DEVIATION REQUEST AND DECISION FORM

Project Name : Cimarron Hills SE Mixed Use Filing No 1 - Subdivision
Schedule No.(s) : 5408007001, 5408007004, 5408007008
Legal Description : See Submittal

SUBDIVISION CONCEPT PLAN

CIMARRON HILLS SOUTHEAST
MIXED USE FILING NO.1

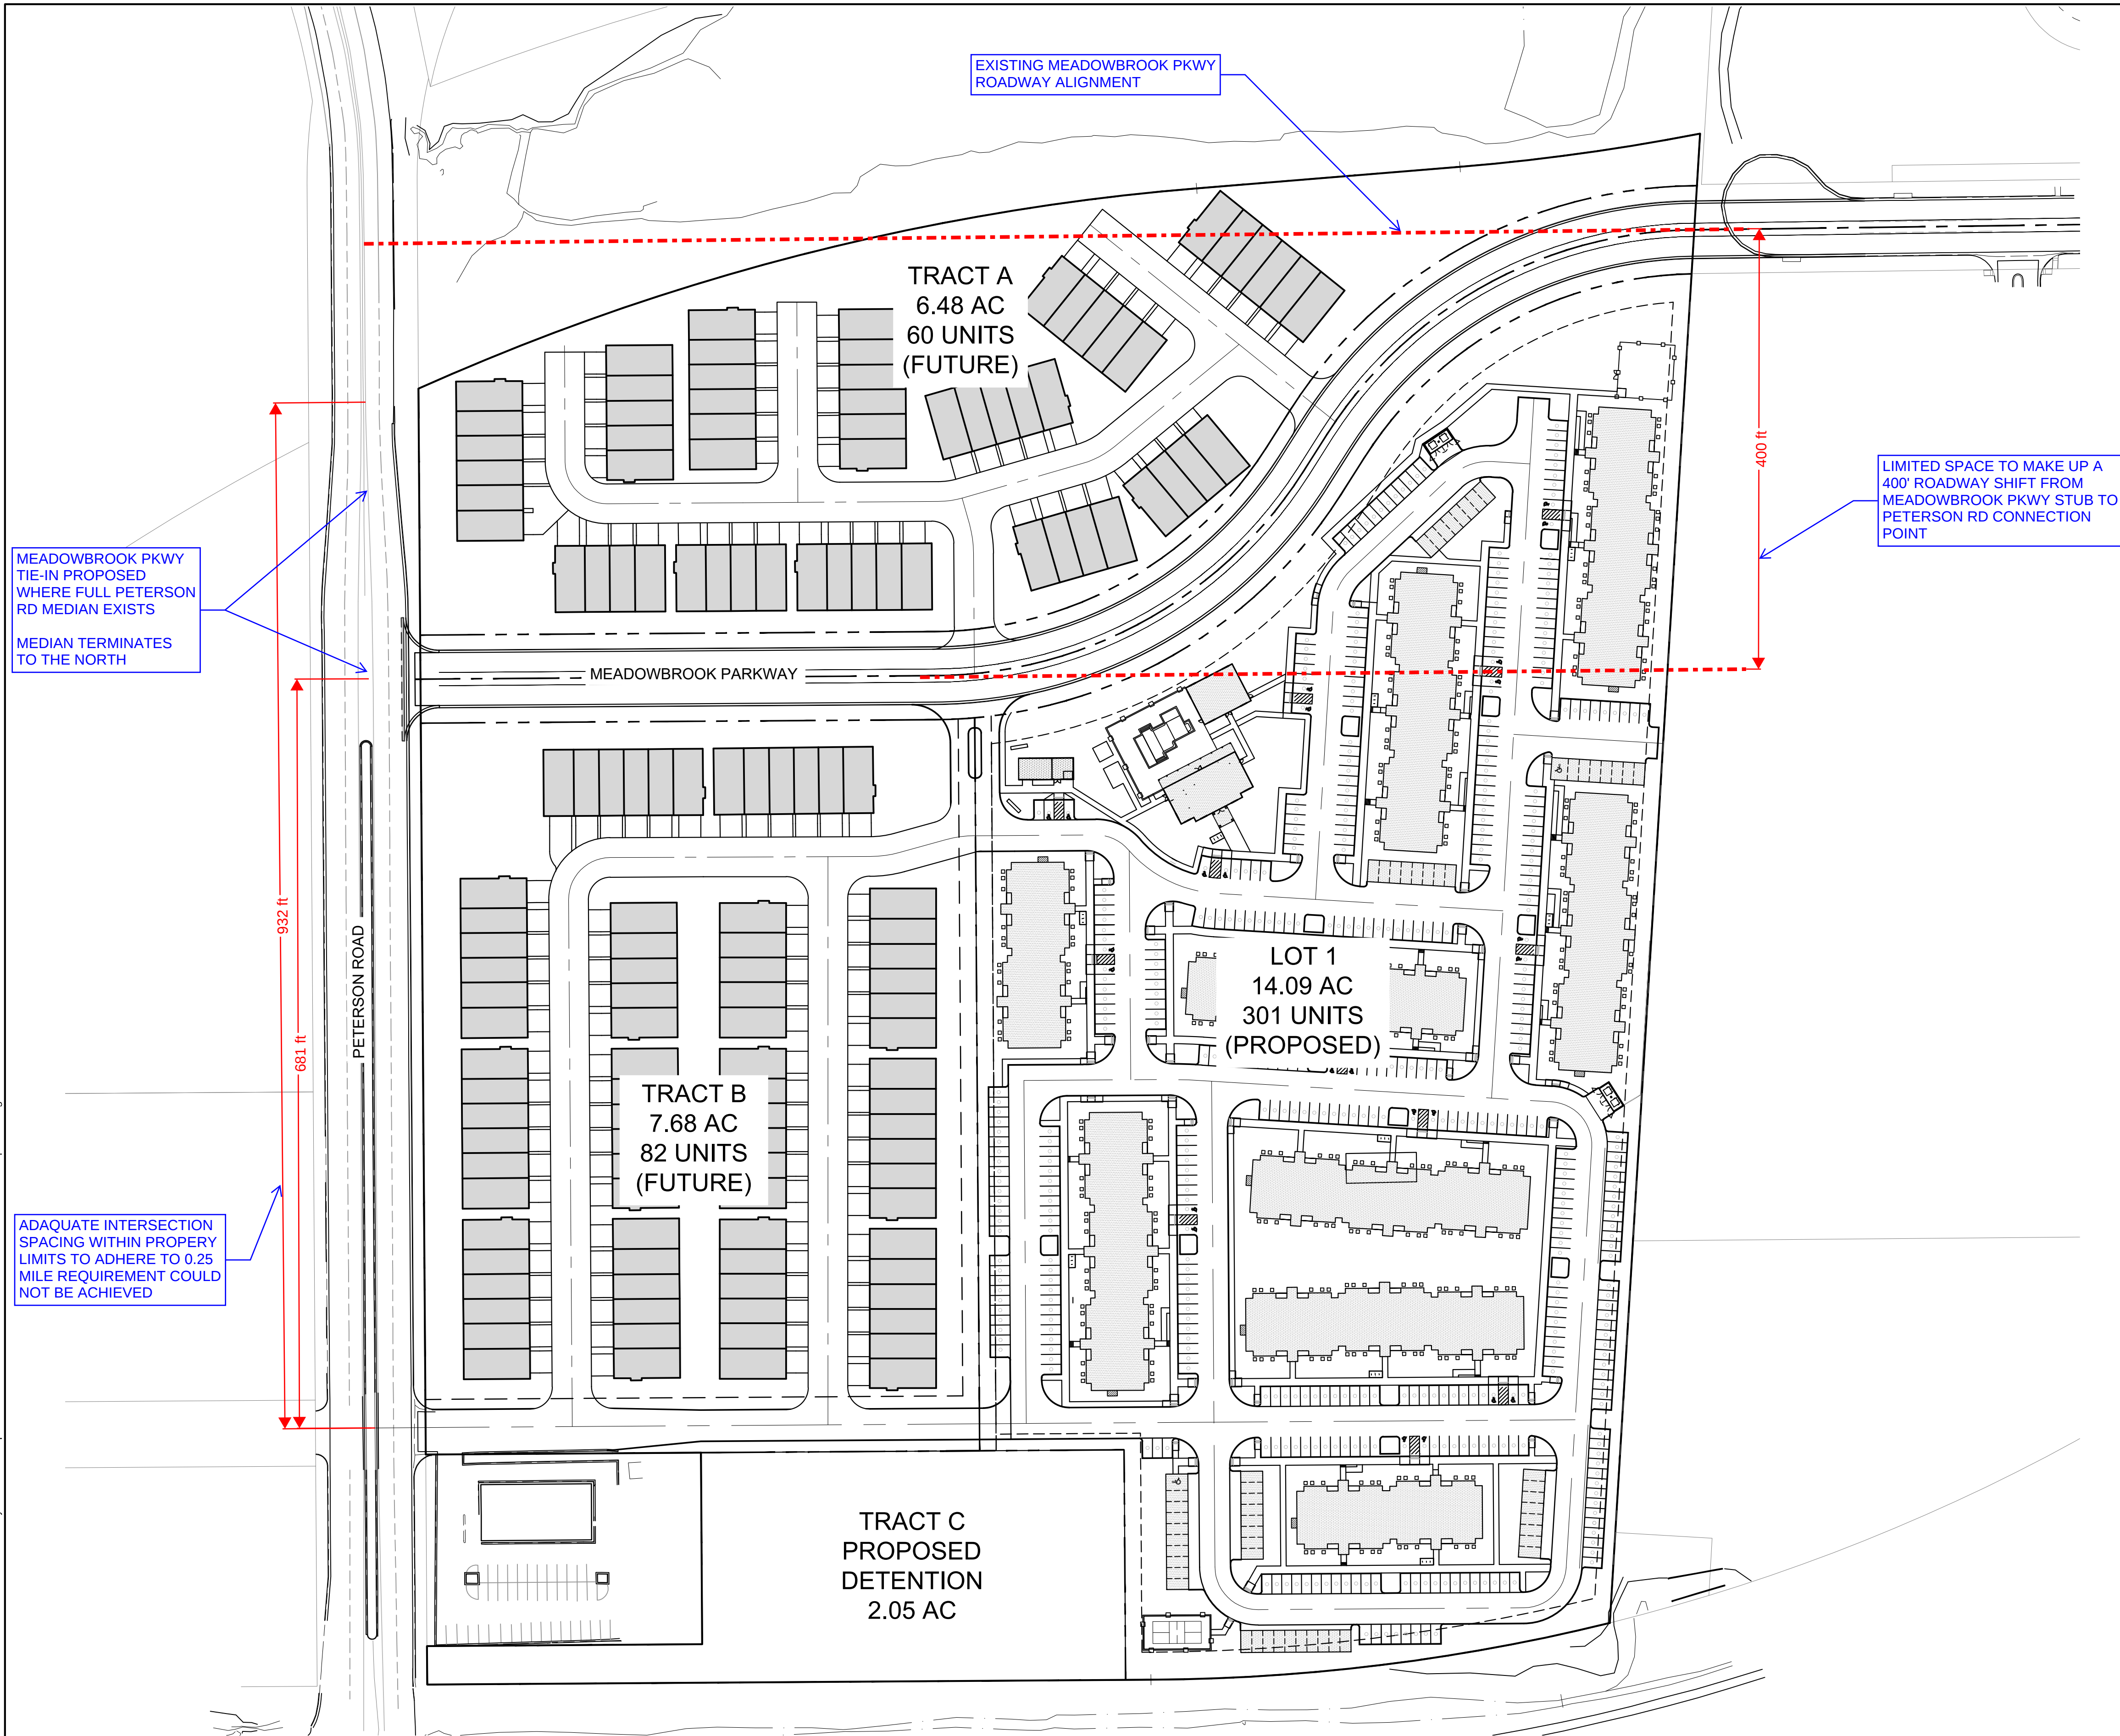
The proposed design of Meadowbrook Parkway extension to Peterson Road will have two (2) 400' curve radiuses used. This deviates from the 565' minimum centerline curve radius requirement found in Table 2-7 of El Paso County ECM for a Non-Residential Collector roadway. There will also be a 40' tangent length between the reverse curves which deviate from the minimum 150' tangent length requirement found in table 2-10. Additionally, the intersection spacing for the connection of Meadowbrook Parkway to Peterson Rd does not meet the 0.25-mile requirement for a Minor Arterial roadway found in Table 2-6. All other roadway specifications horizontally and vertically have been met. The proposed extension of Meadowbrook Parkway is 30 mph.

The first deviation is from the 565' minimum centerline curve radius requirement found in Table 2-7 of the El Paso County ECM for a Non-Residential Collector roadway. The proposed alternative was to provide a 400' curve radius and reduce the speed limit on the Meadowbrook Pkwy extension to 30 mph.

The second deviation is from the 150' tangent length requirement found in Table 2-10 for a Collector roadway. The proposed alternative was to provide a 40' tangent length and reduce the speed limit on Meadowbrook Pkwy to 30 mph.

The third deviation is from the 0.25-mile intersection spacing requirement found in Table 2-6 of the El Paso County ECM for a Minor Arterial roadway. The proposed alternatives were limited due to the spacing from the existing Panamint Ct/ Peterson Rd intersection to the northern boundary of the subdivision being only 0.20 miles apart. The posted speed limit on Peterson Rd for this stretch of roadway is 30 mph, which is less than the 35 mph posted speed listed in table 2-6 of the El Paso County ECM.

This request has been determined to have met the criteria for approval. A deviation from Section 2.2.5, 2.3.2 & 2.3.3 of the ECM is hereby granted based on the justification provided.
